Access Compliance Report

Public Rights-of-Way

Intersection ID: 10023914	Main Street: CONFERENCE_DR	Cross Street: N/A	Location: SE
ADA ID: F07626A5B90B	Ramp Type: Perp	Initial Pass/Fail: Fail	Overall Compliance: No
		Severity Score: 12.5

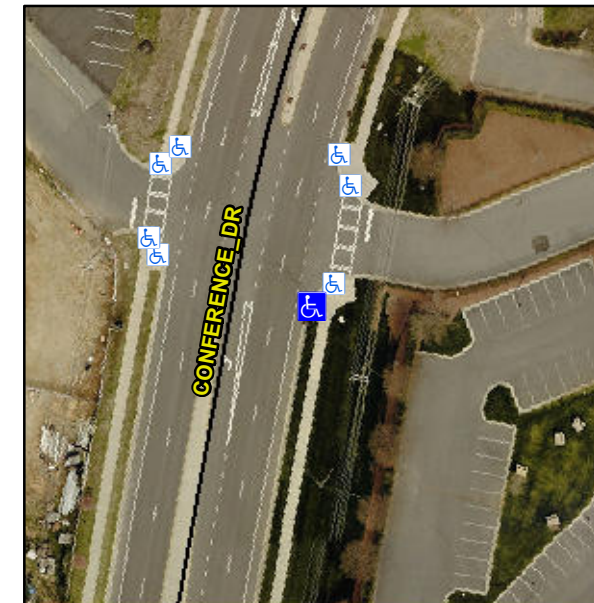
Not Found, R304.2.2

Compliance	Description	Data	Compliance	Description	Data
N/A	Ramp Length (in)	68.0	No	Ramp Slope (%)	9.0
Yes	Ramp Width (in)	48.0	Yes	Ramp XSlope (%)	1.3
N/A	Flare Type LT	N/A	N/A	Flare Type RT	N/A
N/A	Flare Slope LT (%)	N/A	N/A	Flare Slope RT (%)	N/A
N/A	Flare Traversable LT?	N/A	N/A	Flare Traversable RT?	N/A
N/A	Landing Length (in)	N/A	N/A	DWS Provided?	N/A
N/A	Landing Width (in)	N/A	N/A	DWS Contrast?	N/A
N/A	Landing Slope (%)	N/A	N/A	DWS Length (in)	N/A
N/A	Landing X Slope (%)	N/A	N/A	DWS Full Width?	N/A
N/A	Landing Curb? (Y/N)	N/A	N/A	DWS Offset (in)	N/A
N/A	Shared Landing?	N/A			
N/A	Gutter Ponding?	N/A	N/A	Gutter Slope (%)	N/A
N/A	Gutter Lip Ht (in)	N/A	N/A	Gutter X Slope (%)	N/A
N/A	Painted X Walk1?	No	N/A	Painted X Walk2?	N/A
	X Walk 1 Direction	To NW		X Walk 2 Direction	N/A
N/A	X Walk 1 Width (in)	N/A	N/A	X Walk 2 Width (in)	N/A
	X Walk 1 Slope (%)	1.5		X Walk 2 Slope (%)	N/A
	X Walk 1 X Slope (%)	1.5		X Walk 2 X Slope (%)	N/A

Remove & Replace Entire Ramp.
